DOCUMENT - 2026-264T

**Interior and Exterior Renovations at Peel Regional Police 12 Division, 4600
Dixie Road, Mississauga
ADDENDUM NO. 2**

Please see the SWBD 'PP-O' nameplate image attached:

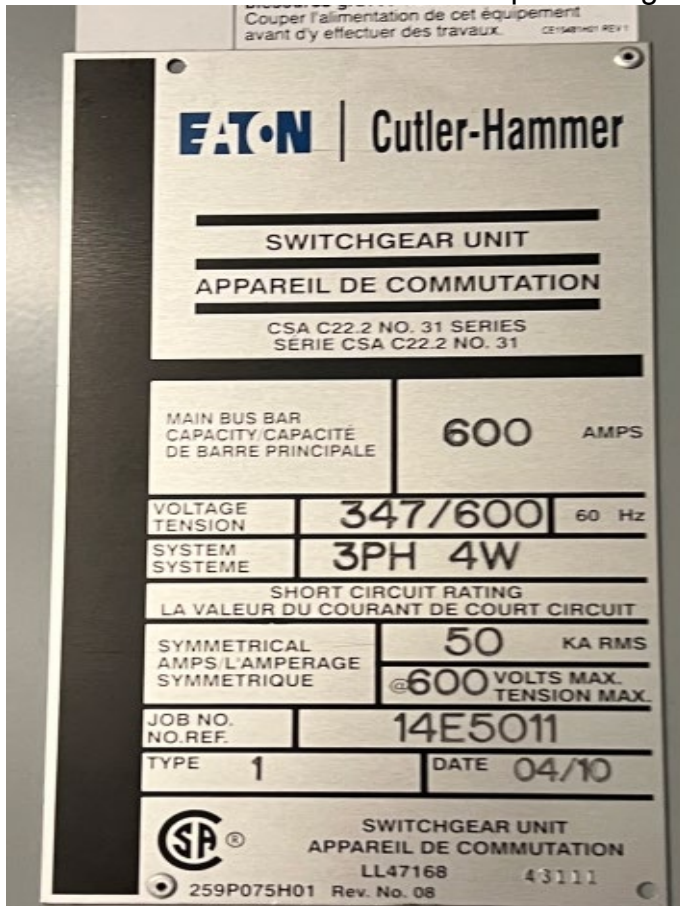
Please provide details & make of SWBD PP-O as we have to supply & install new 50A-2P circuit breaker.
